<b>Docket Number:</b>	17-BSTD-01
<b>Project Title:</b>	2019 Building Energy Efficiency Standards PreRulemaking
<b>TN #:</b>	220506
<b>Document Title:</b>	Comments on Variable Exhaust Flow and Controls
<b>Description:</b>	Comments from Mike Wolf and Ken Kuntz
<b>Filer:</b>	Michael L. Wolf, P.E.
<b>Organization:</b>	Greenheck Group
<b>Submitter Role:</b>	Public
<b>Submission Date:</b>	8/2/2017 11:17:01 AM
<b>Docketed Date:</b>	8/2/2017

## **RE: Docket Number 2017-BSTD-01; Variable Exhaust Flow Control (TN#-217909)**

**Chart 1: Typical Lab Exhaust Fan Types**

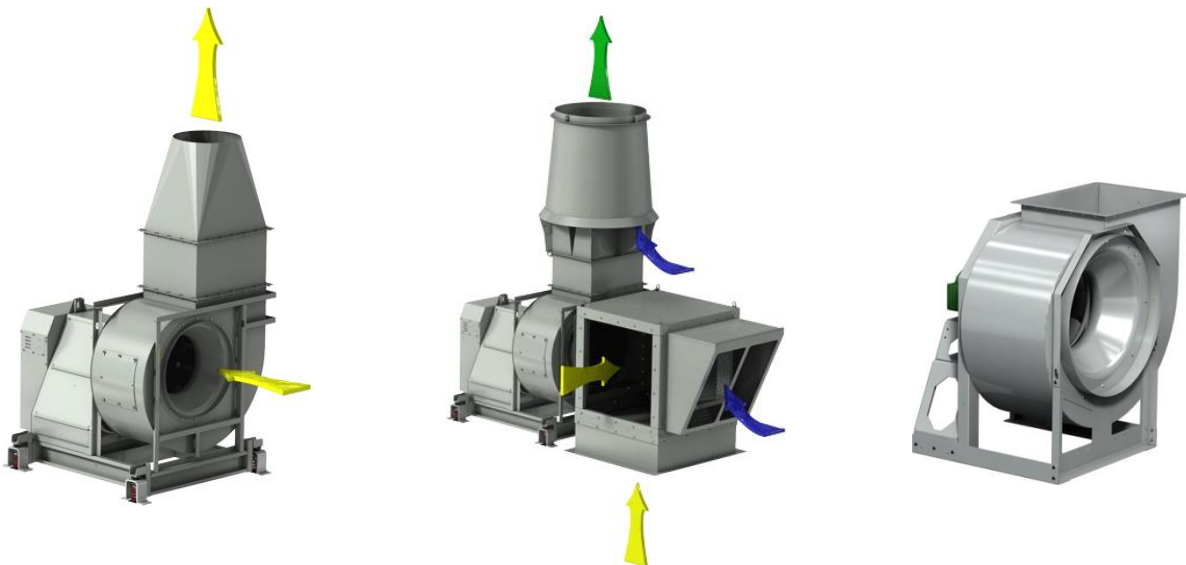
\*Commentary: It is not clear to the reader where the proposed value limit of 0.45 watts/cfm came from. After performing multiple fan selections for common lab exhaust design points of 10,000 cfm and 20,000 cfm, the 0.45 watts/cfm does not appear to be achievable even with the most efficient fan for a given operating point including fan only without nozzles.

Table 1 below shows the performance and energy usage at the two design points for a variety of commonly used lab exhaust fans (see chart 1 for renderings of each fan type analyzed). Each fan listed is the most energy efficient selection for that style fan meeting the design point and a minimum of 3000 fpm exit velocity. Selections for Table 1 were made using fan selection software. Each fan type had multiple selection options.

Based upon these results shown in Tables 1 and 2 above, we recommend a level of 0.65 watts/cfm for a dedicated lab exhaust fan system. Using the 0.65 watts/cfm requirement for the examples in Tables 1 and 2 above will eliminate inefficient selections without the need for additional monitoring equipment.
